Decision on an application to change/cancel conditions of a resource consent under section 127 of the Resource Management Act 1991

Application numbers: LUC60010513-J & SUB60035991-J

Applicant: AV Jennings Hobsonville Pty Limited

Site address: 226 Grand Drive, Orewa 0931, 47 Ara Hills Drive, Upper Orewa 0992

TITLE
**PROPOSED ROAD LAYOUT
PLAN**

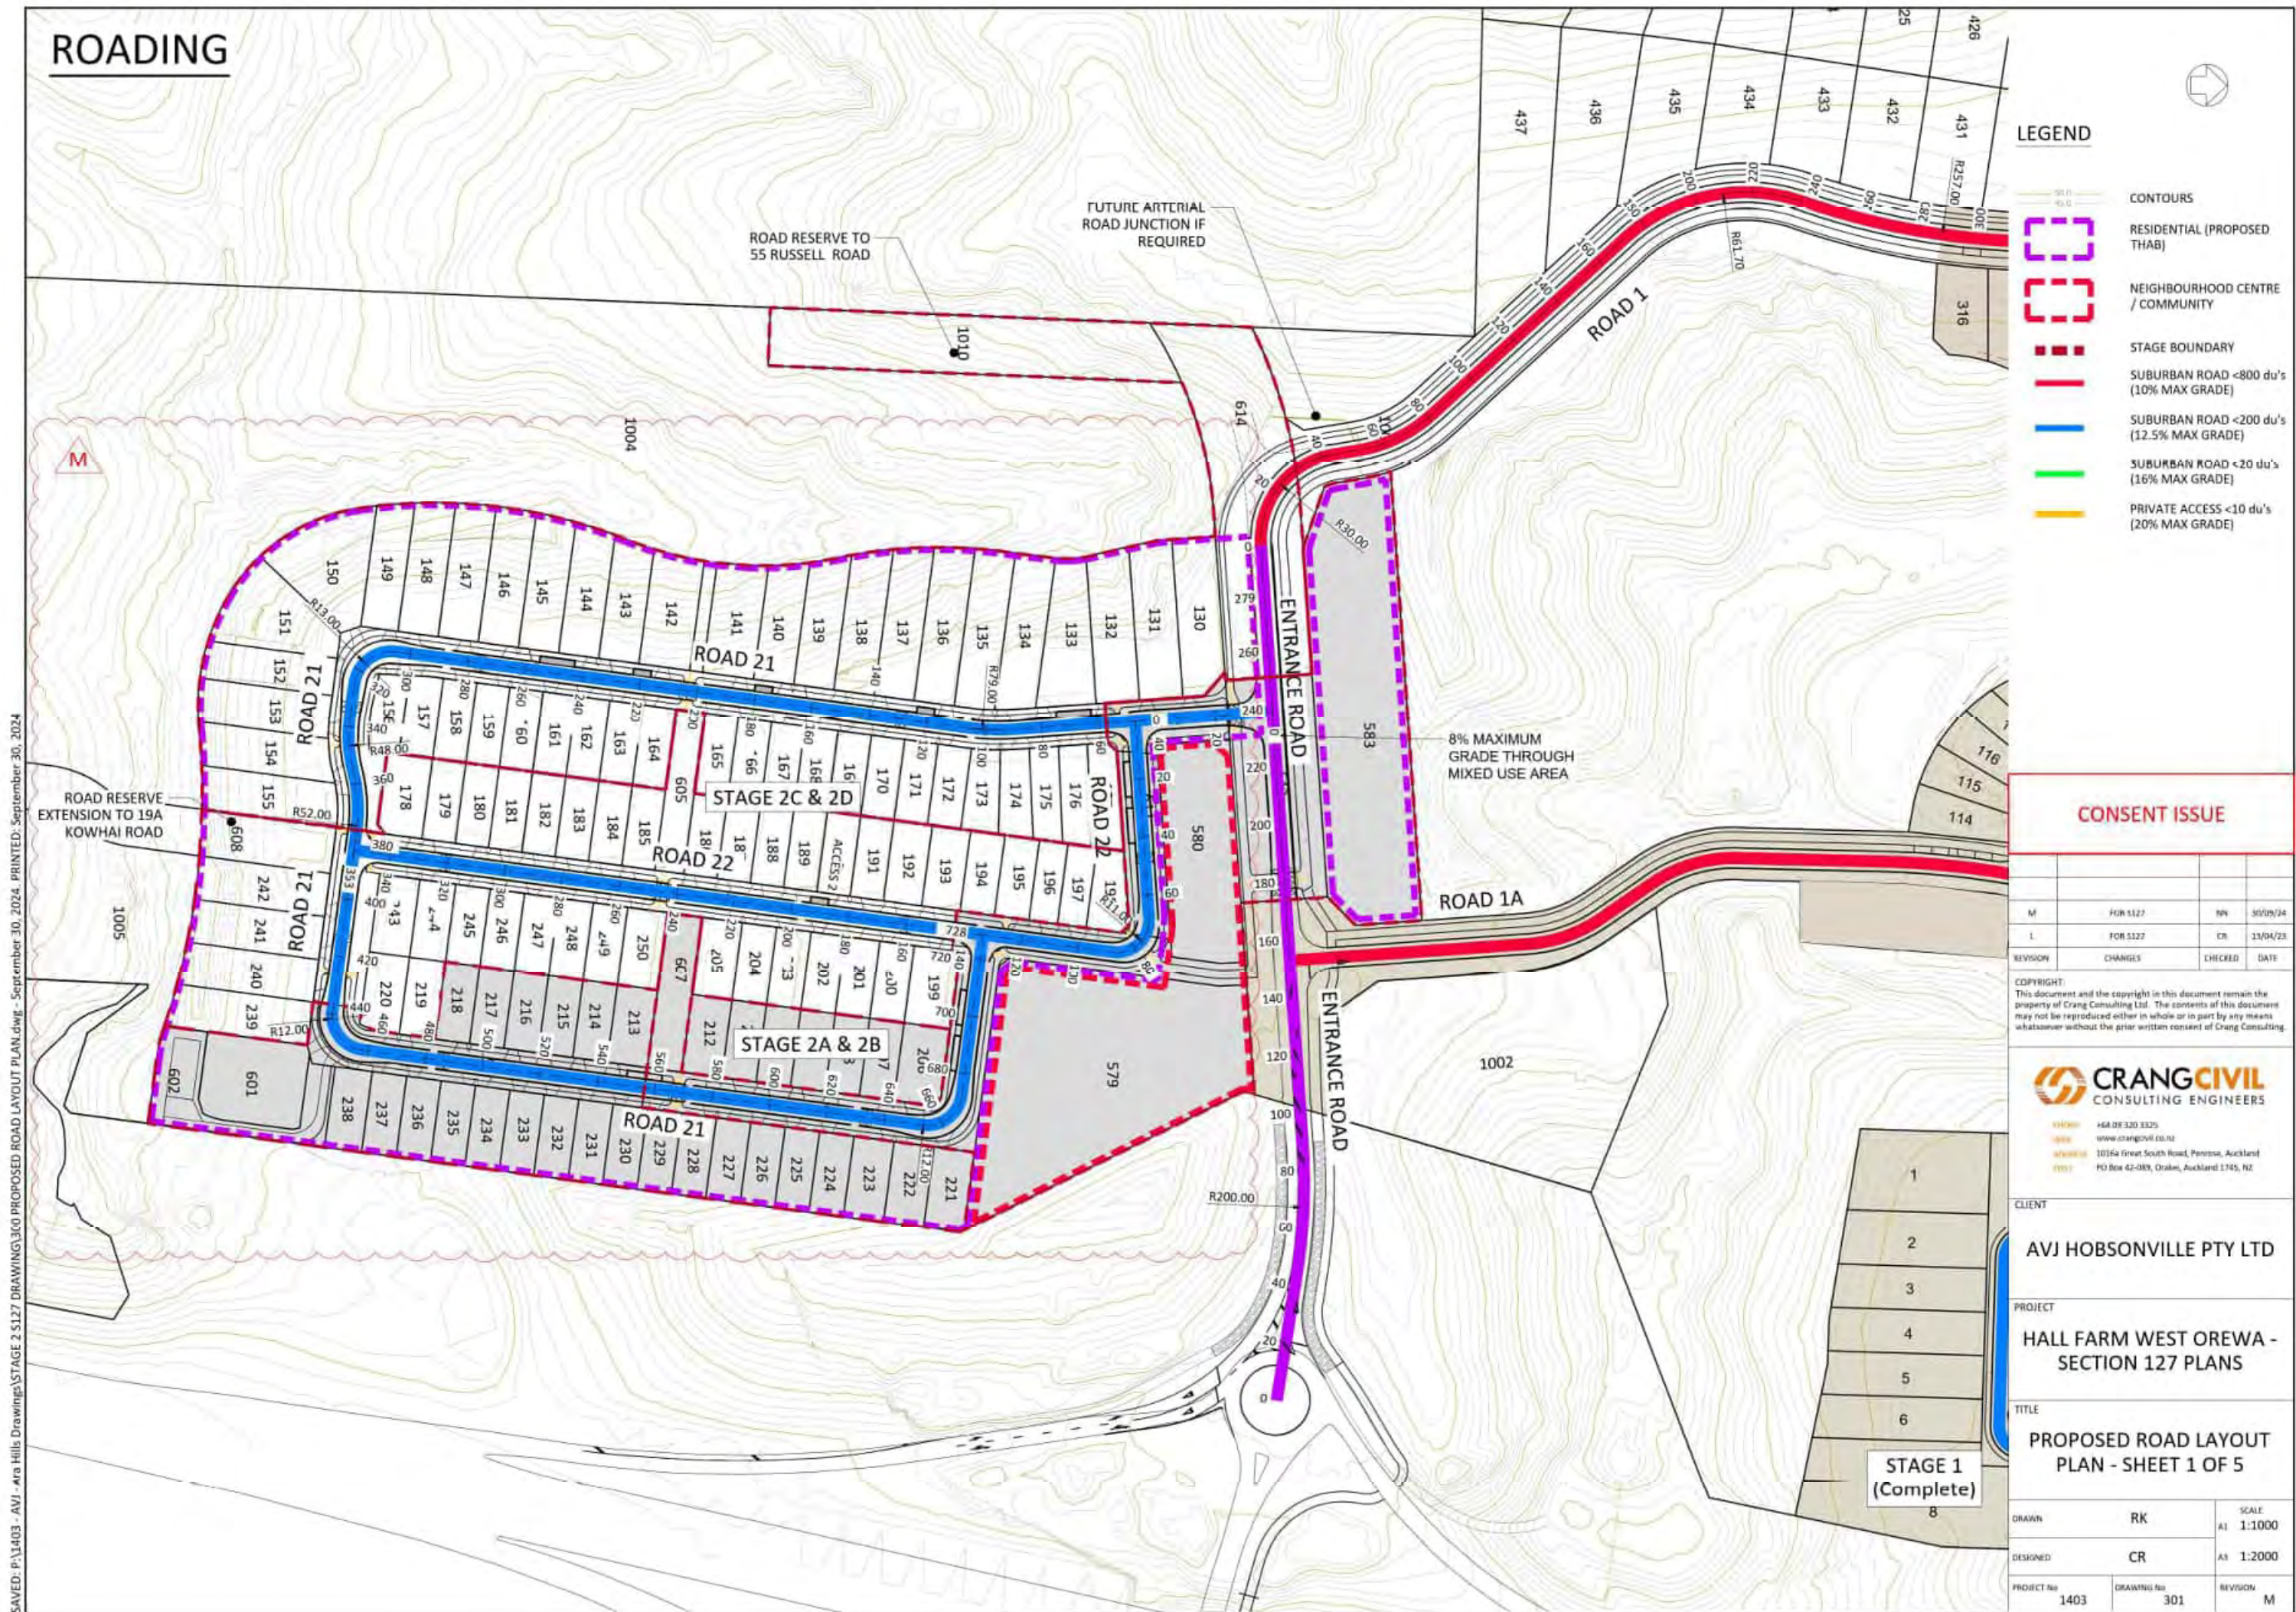
3. In the event of any inconsistency between the approved drawings and supplementary documentation, the approved drawings will prevail. In the event of any inconsistency between the approved drawings, plan titled "Proposed Road Layout Plan", drawing no.: 300, Rev ~~L~~M, prepared by Crang Civil Limited will prevail.

3. In the event of any inconsistency between the approved drawings and supplementary documentation, the approved drawings will prevail. In the event of any inconsistency between the approved drawings, plan titled "Proposed Road Layout Plan", drawing no.: 300, Rev M, prepared by Crang Civil Limited will prevail.

DRAWING No SP494_2 **SHEET** 6 of 7 **REVISION** P

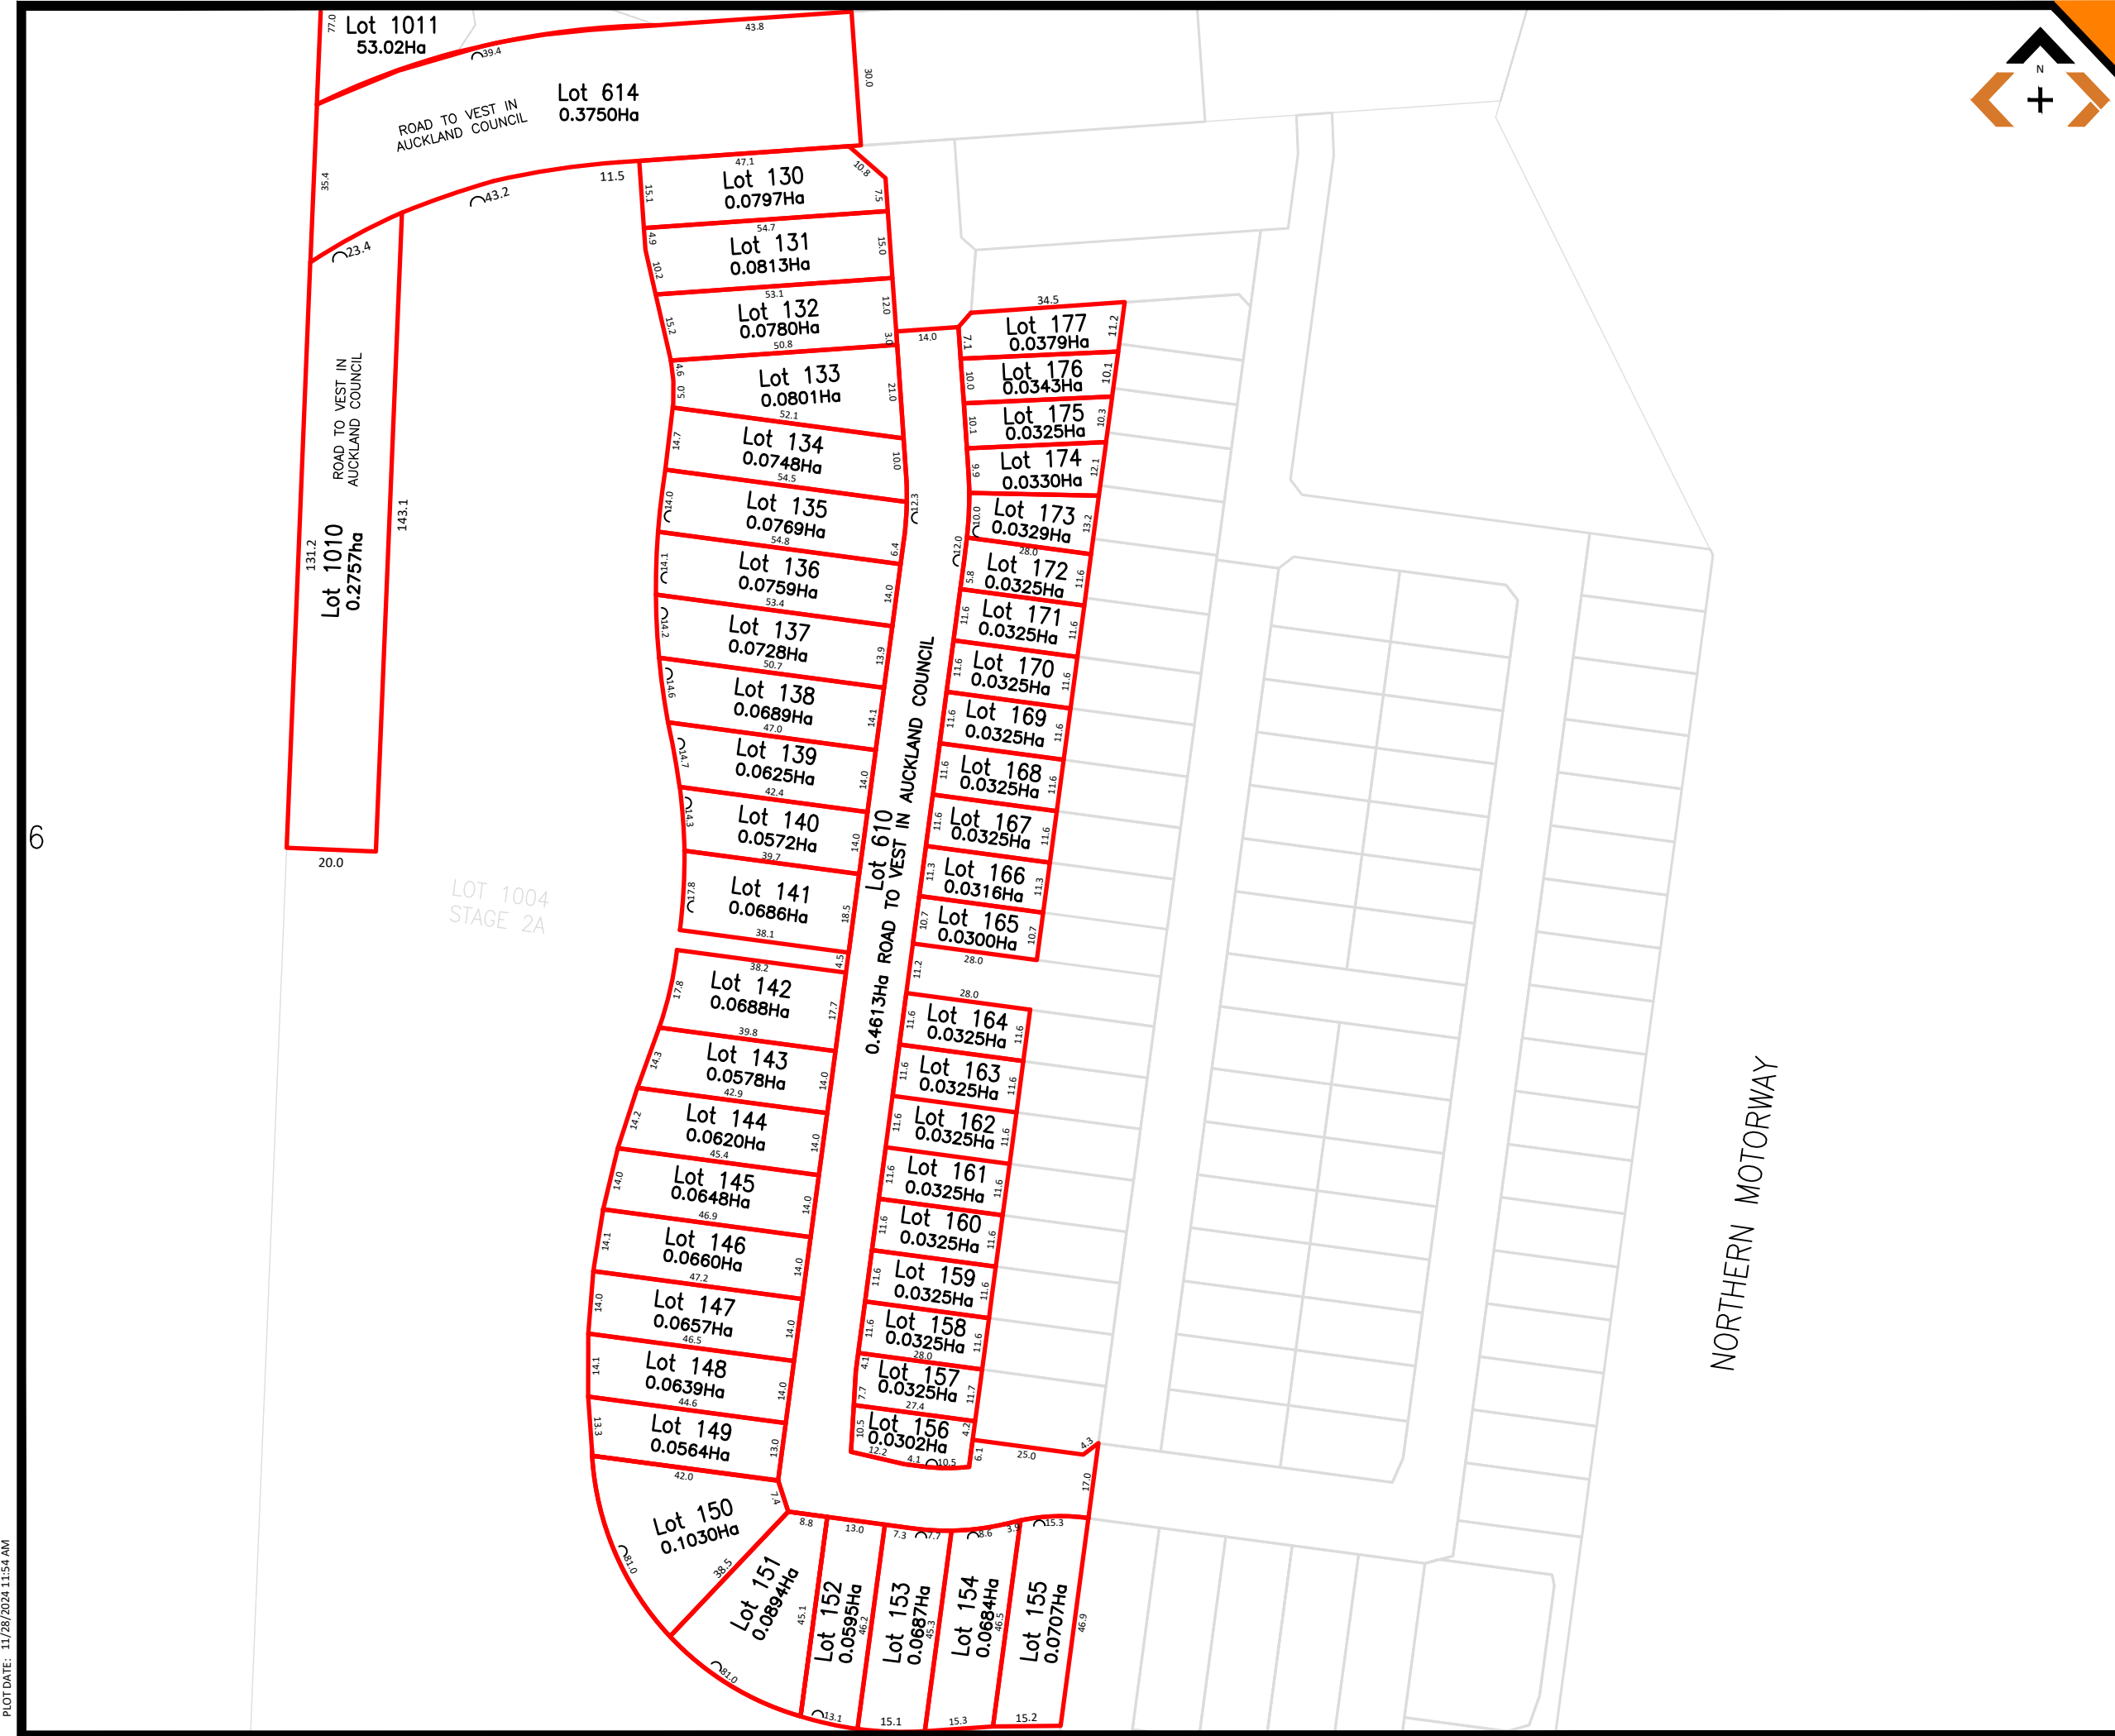
To vary conditions of resource consents LUC60010513-H and SUB60035991-I under the original bundled consent BUN20441333 to allow for eight additional lots due to the removal of the private pocket park (consented Lot 605), the reorientation of lots adjacent to it, along with reductions in lot widths and amendments to the walkway lot between contested Lots 140 and 141. Conditions to be varied are 1, 2, 3, 9, Table 1 of 116; as well as relevant plans within Appendix 1.

- a. The effects on the receiving environment with regards to the proposed changes are negligible as the proposed variation seeks to introduce eight new lots within Stages 2 (Stages 2C and 2D) due to the loss of a pocket park (Lot 605 as consented) and the reduction of lot sizes in general that allow for the increased yield within this stage. The walkway between lots 140 and 141 will also be reduced in size. The changes to the consented engineering, scheme and landscaping plans are relating these changes. There is extensive landscaping and open areas provided within and around the area to ensure that residential amenity is maintained. The proposal will maintain the overall anticipated residential character, open space provisions, and amenity values expected in the area.
